# Addendum / Addenda

Project Description / Description de projet <b>M-38 Acoustics Facility - Phase 3</b>		
Solicitation No./N° de sollicitation <b>18-22095</b>	Project No./N° de projet <b>5310</b>	W.O. No./N° d'ordre de travail <b>A1-010300-01-01-01</b>
Departmental Representative / représentant ministériel <b>Allan Smith</b>		Date <b>January 30, 2019</b>
<b>Notice:</b> This addendum shall form part of the tender documents and all conditions shall apply and be read in conjunction with the original plans and specifications.		<b>Nota:</b> Cet addenda fait partie intégrale des dossiers d'appel; toutes les conditions énoncées doivent être lues et appliquées en conjonction avec les plans et les devis originaux.

18-22095 Addendum #2 Questions and answers

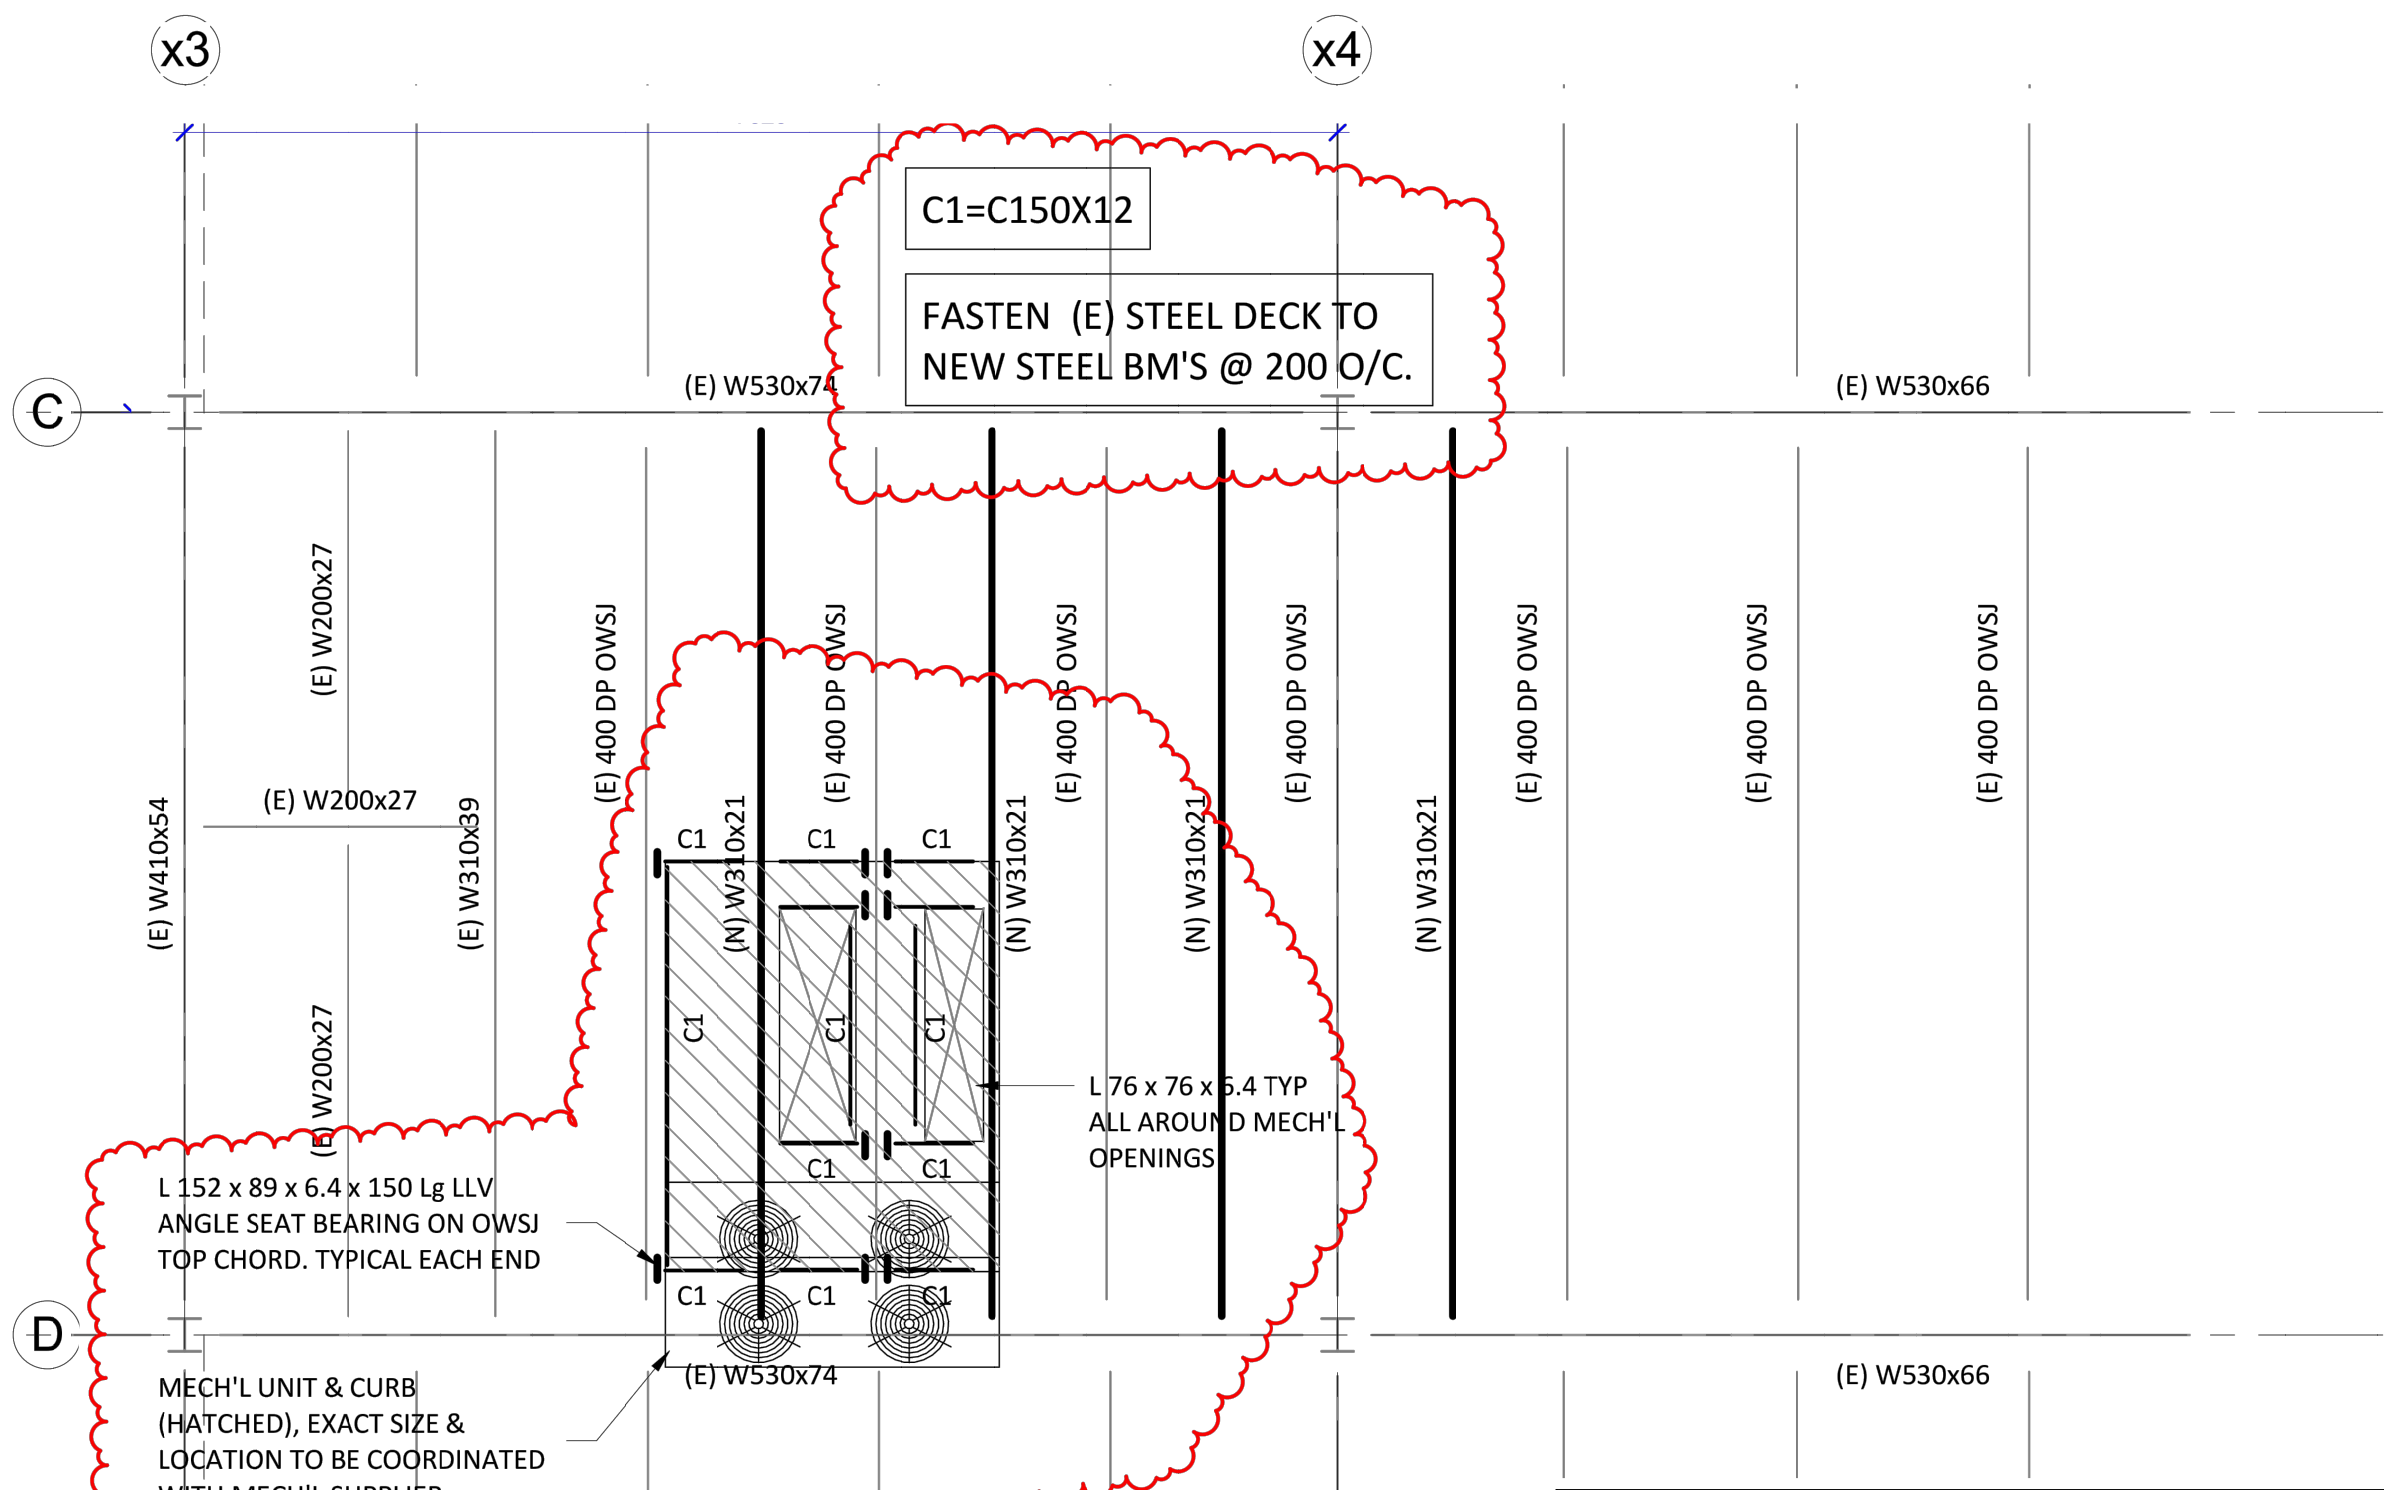
Revised mechanical unit framing on S103

CONTROLGARD DOUBLE COMPOUND  
 CHAIN OPERATED ROLLING DOOR  
 JOB AREAS

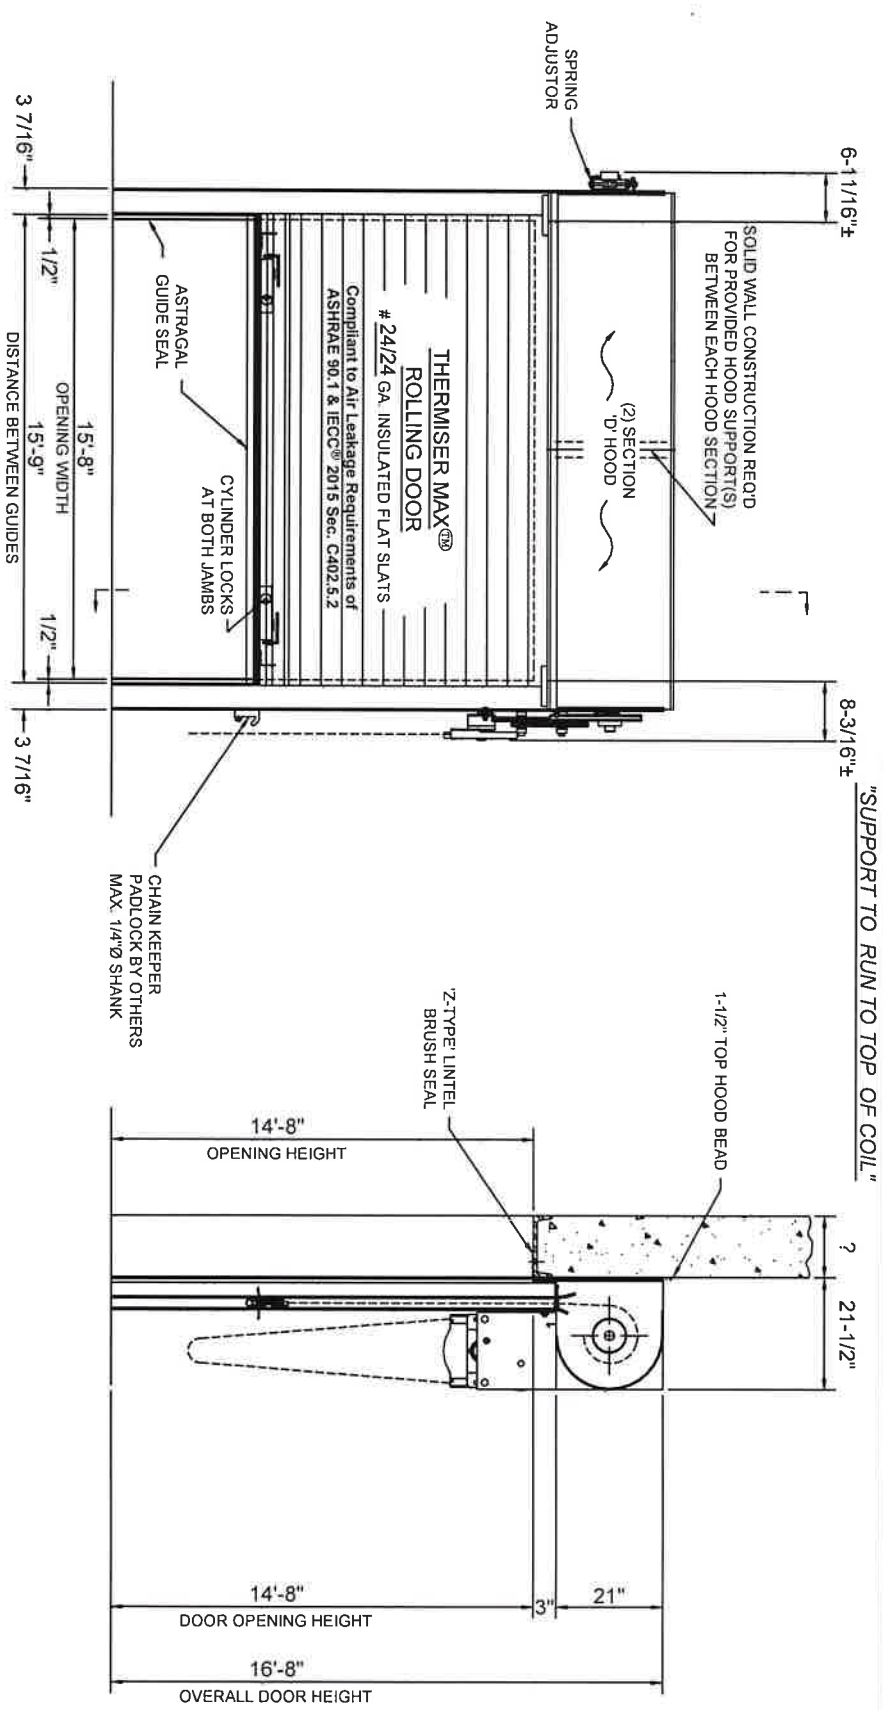
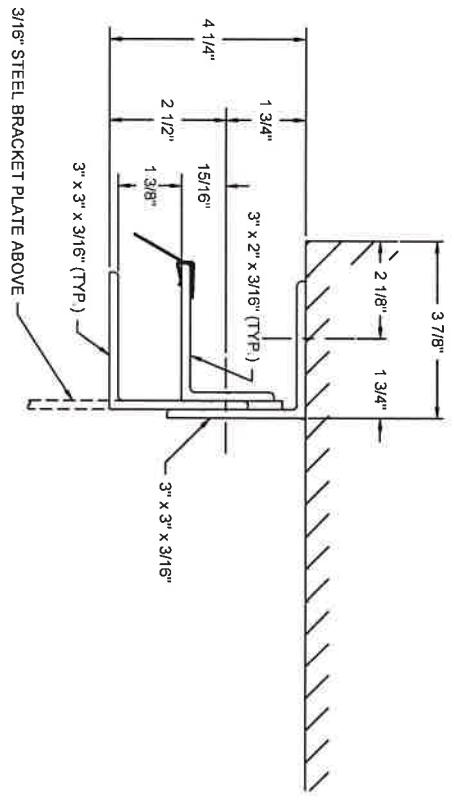
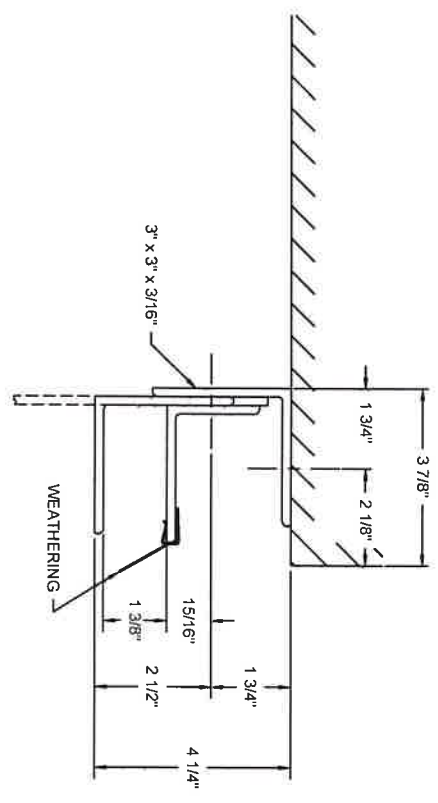
- 14 Refer to notes 11 & 12 on ASK03. Overhead door operators are to be installed by the contractor. The make and model of the door including dimensions have been provided in notes 11 and 12 on the drawing. Contact for manufacturer of door has also been provided in note 11 and 12. Shop drawings are attached for reference.

1 SITE PLAN  
ASK03 1:250

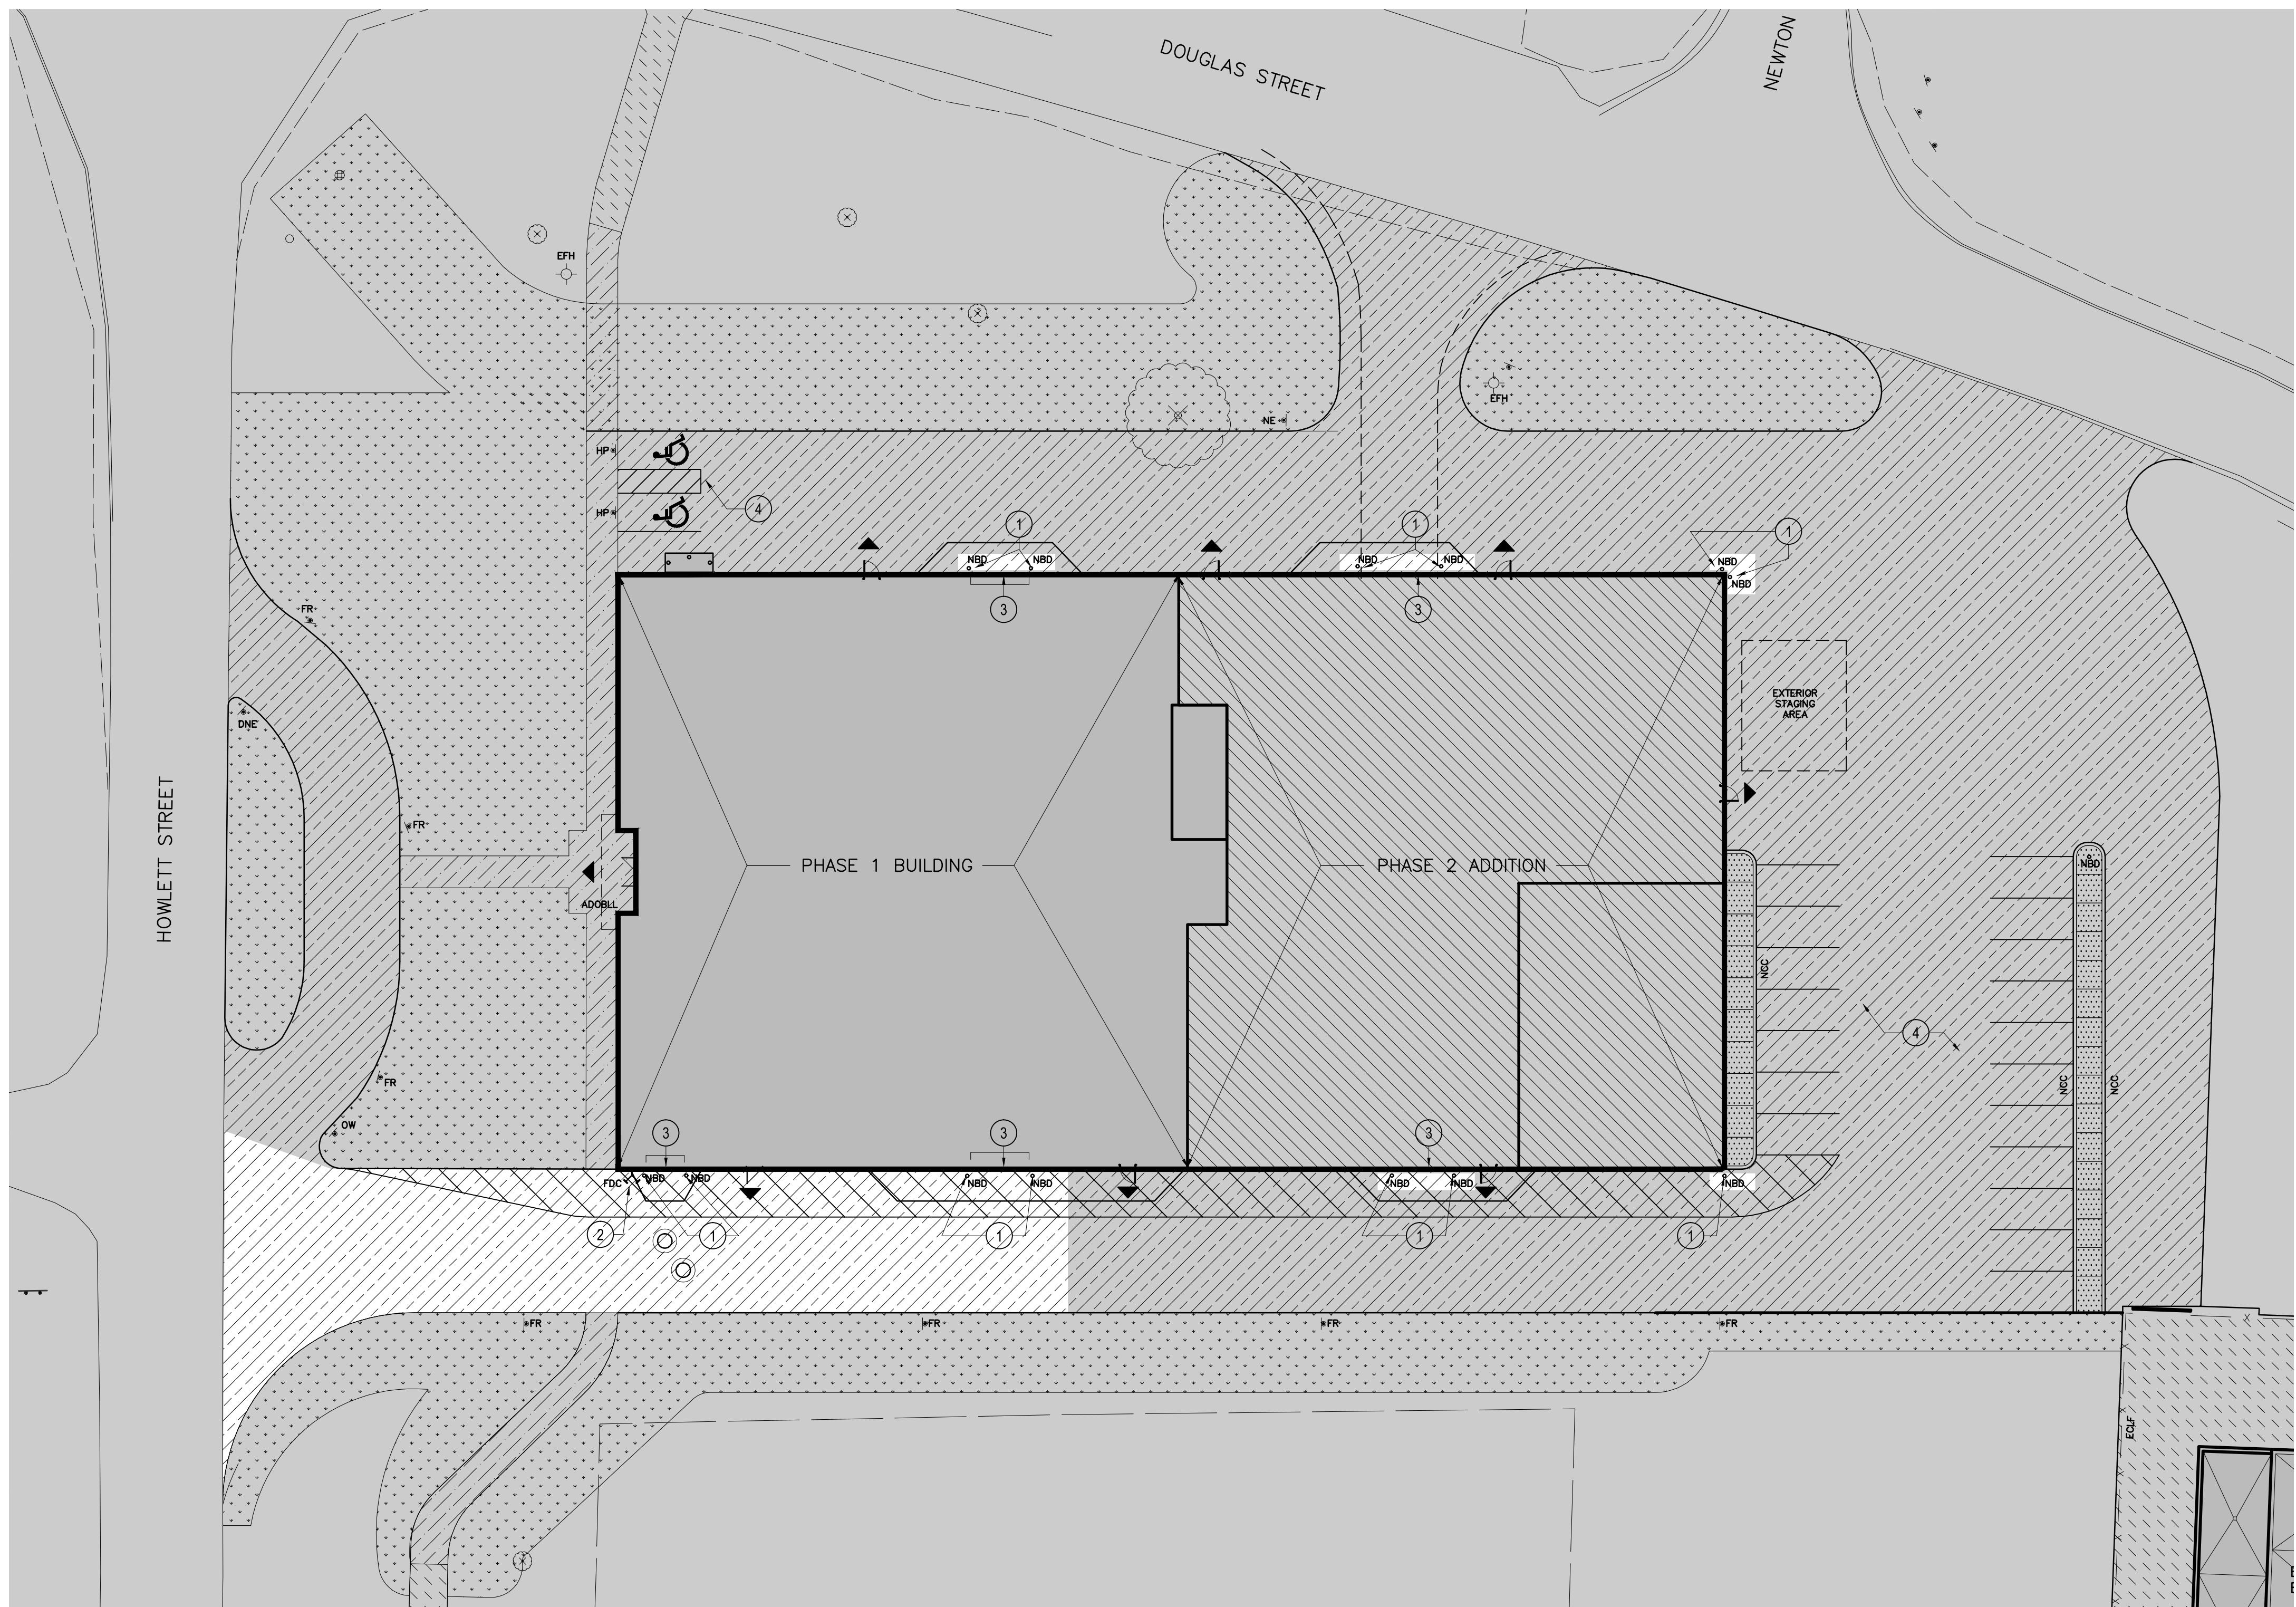
- 13 Reference note #9 on ASK03. New granular B brought up to final asphalt grading elevation is by contractor. Civil Drawing C1 is included in this addendum along with a civil engineer site instruction.

A: **Refer to detail 4/ASK03 for information related to Owner supplied bollards. For Civil information refer to Civil Site Instruction C-01.**

Provide new Granular B Type II brought up to final asphalt grading elevation at location shown on Architectural Drawing ASK03. Granular B Type II to be placed in maximum 200mm thick lifts, compacted to 100% SPD. Civil Drawing C1 dated 2018-03-21 'Revised Grading' is attached for reference only in determining final asphalt grading elevations.
